APPLICATION FOR PERMIT TO DRILL OR REENTER

8. Lease Name and Well No.
Hawk B-10 #11

SUNDRY NOTICES AND REPORTS ON WELLS
Do not use this form for proposals to drill or to re-enter an abandoned well. Use Form 3160-3 (APD) for such proposals.

Apache Corporation hereby requests your waiver of the requirement that a remote control for the accumulator be used on the 3000 psi BOP provided for in our APD, dated 5-10-01. Also, attached is a revised drawing of the BOP to be used on this well, as the one submitted with our APD was in error.

EXHIBIT "G"

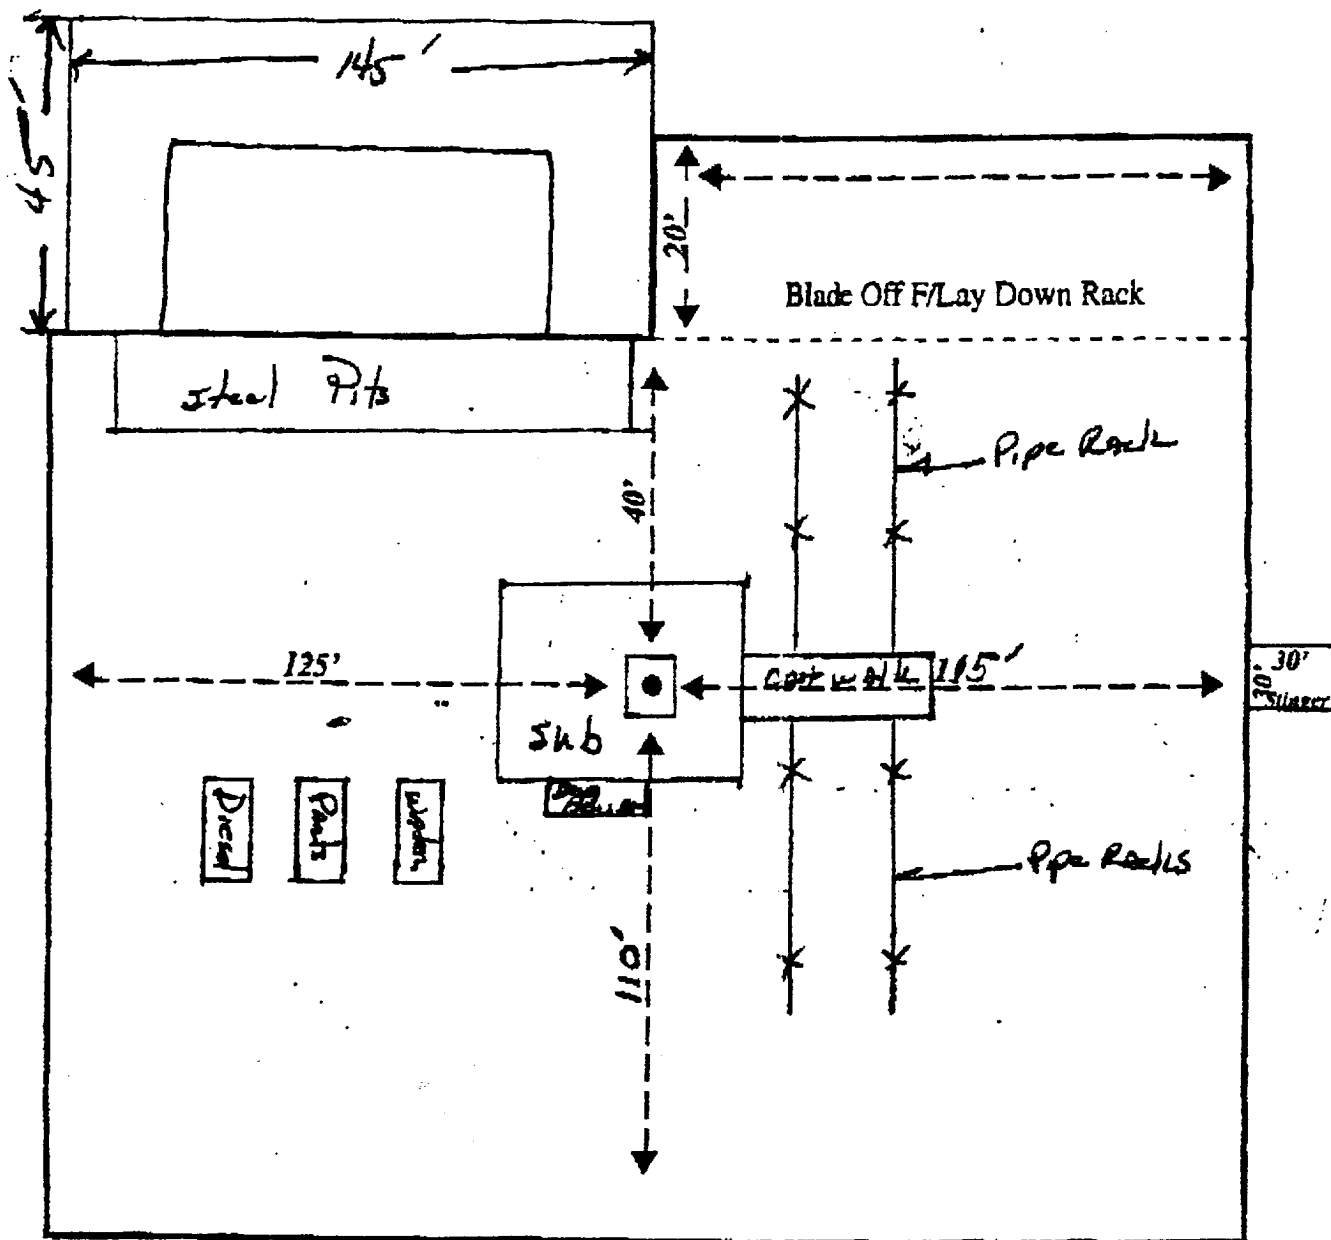
Note: The reserve pits will be moved to The South side of The pad due to topography constraints.
